### **REMARKS**

**Amendments to the Drawings:**

FIG. 1

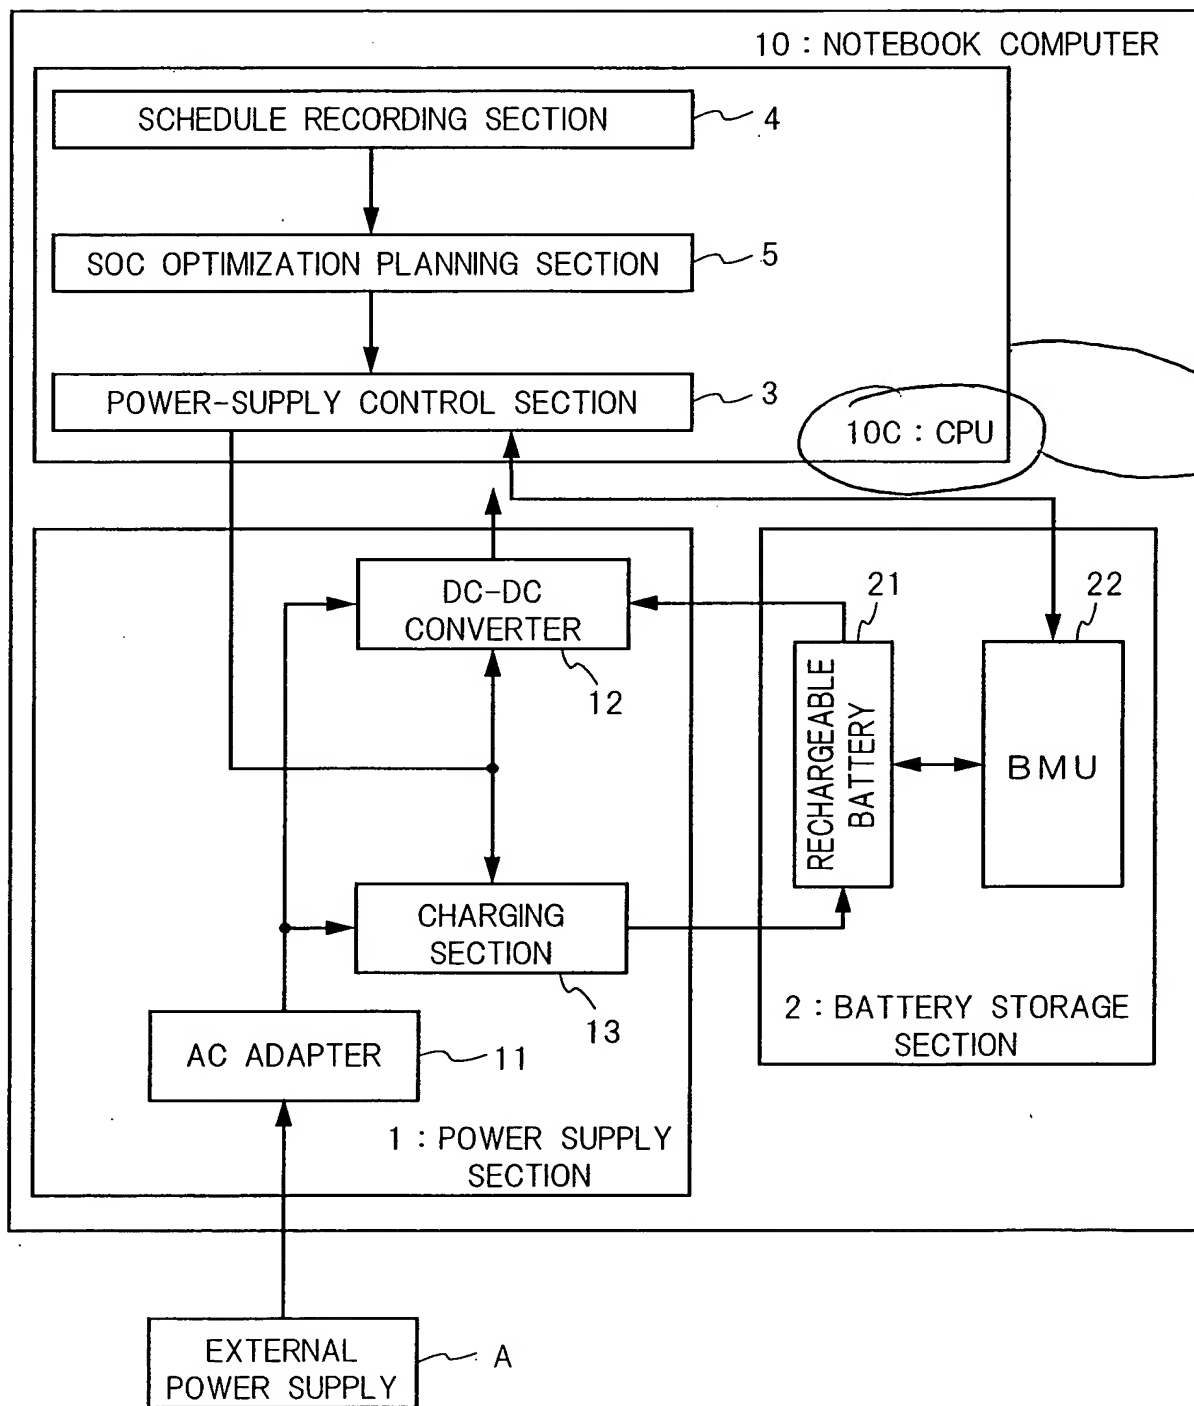
The Examiner objected to the figures because the figures do not show every feature of the invention specified in the claims. Applicant has attached an Appendix to this Amendment, including replacement sheets and an annotated sheets for Figs. 1 and 4 showing changes for the Examiner's approval. The CPU 10C and 30C is shown in both Figs.1 and 4, the battery storage section 2 is shown in Fig 1, the power supply section 1 is shown in Fig. 1, the charge state optimization planning section 5A is shown in Fig 4. Having made the requested corrections, Applicant respectfully requests reconsideration and withdrawal of the objections to the drawings.

The attached sheets of drawings include changes to Figs. 1 and 4. These sheets, which include Figs. 1 and 4 replace the original sheets including Figs. 1 and 4. In Figs. 1 and 4, the elements included in the CPU have been enclosed in a box labeled CPU.
